## **Service Bulletin**

**No. :** MZ08-005

**Model:** SR4001, SR5001

**Subject:** Information on the addition of a Service extension cable.

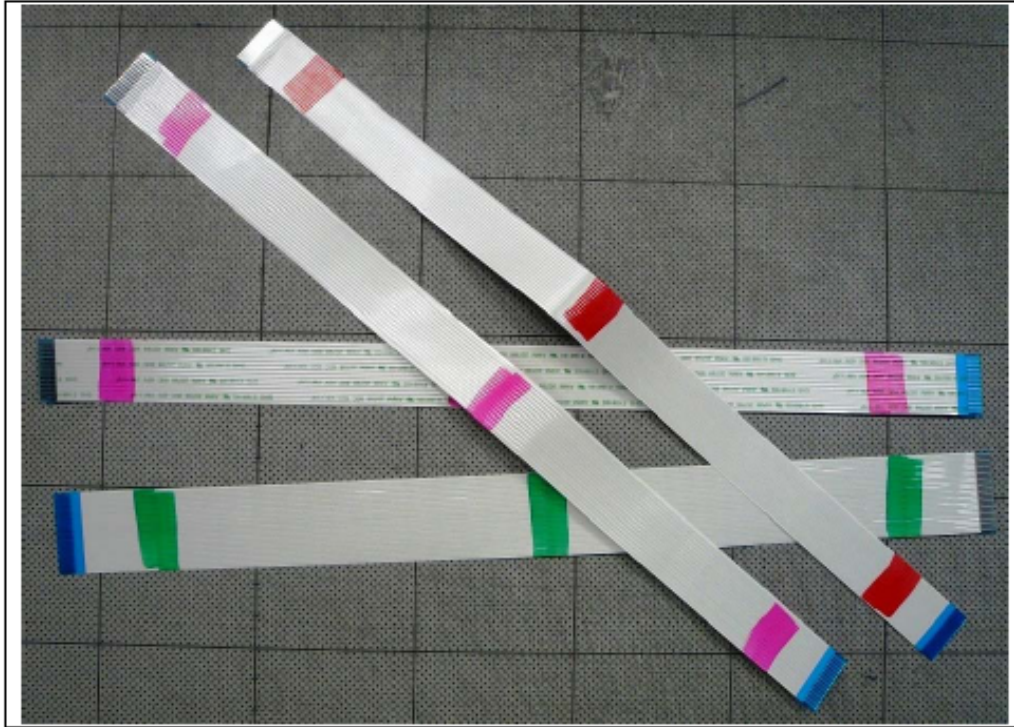
**Symptom:** The part number of Extension FFC will be added to the Service spare parts. The PWB can now be removed from the unit and repaired.

**Solution:** The Extension FFC comes in several types depending on the number of PINs and the length. That is why each comes marked in the same color with the location specified on the wiring diagram (below). Please check the attached wiring diagram before use.
